# Thor Motor Coach Recall Repair Instructions

Recall #	17V-522		
Description/Title:	<b>LP Rubber Hose</b>		
Affected Product Line(s):	<b>Certain 2018 Chateau, Four Winds, and Freedom Elite motorhomes</b>		
Service Campaign # :	<b>RC000144</b>	Released Date:	<b>10/4/2017</b>
Failure Code:	<b>Inspect: TMCRC80468Y Repair: TMCRC80468V</b>	Document Date:	<b>10/4/2017</b>
Time Allowed:	<b>Inspect: 0.2 Repair: 0.4</b>	Document Revision:	<b>A</b>

**Figure 1**

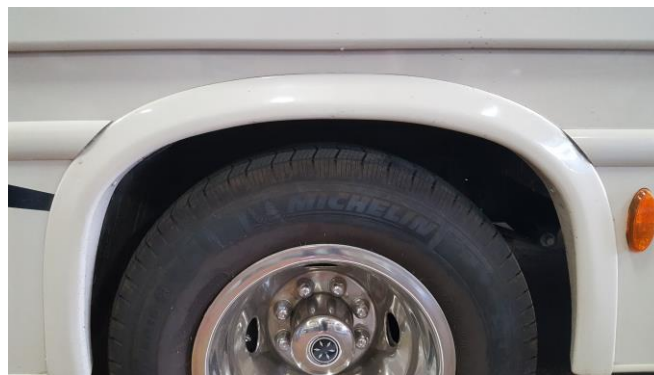
Inspect the routing of the rubber LP hose in the wheel well to determine the need for additional p-clamps or relocation of p-clams for proper securement to eliminate potential for sagging. (Figure 1)
